WTL3 - Replacing Seal for Roof Module (Workshop Campaign)

Model Line: **Cayenne Electric (X1A)**

Model Year: **2026**

Concerns: **Roof assembly gasket**

Roof assembly gasket

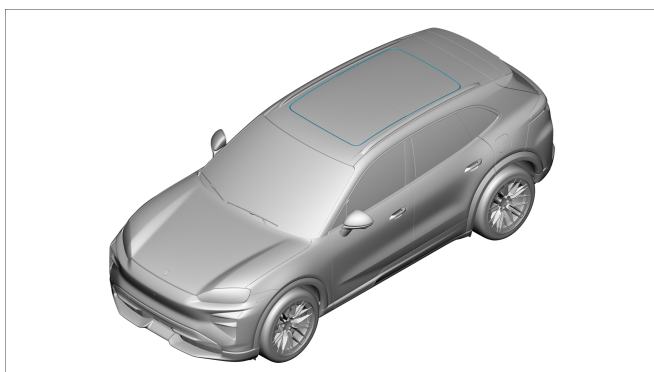
Information: **On the affected vehicles, there is a possibility that the front left and right roof module seal was not applied correctly.**

As a result, the seal is not durable and can partially detach. Over the service life of the vehicle, this may lead to leaks in the area of the roof module.

Action: Replace seal on roof module.
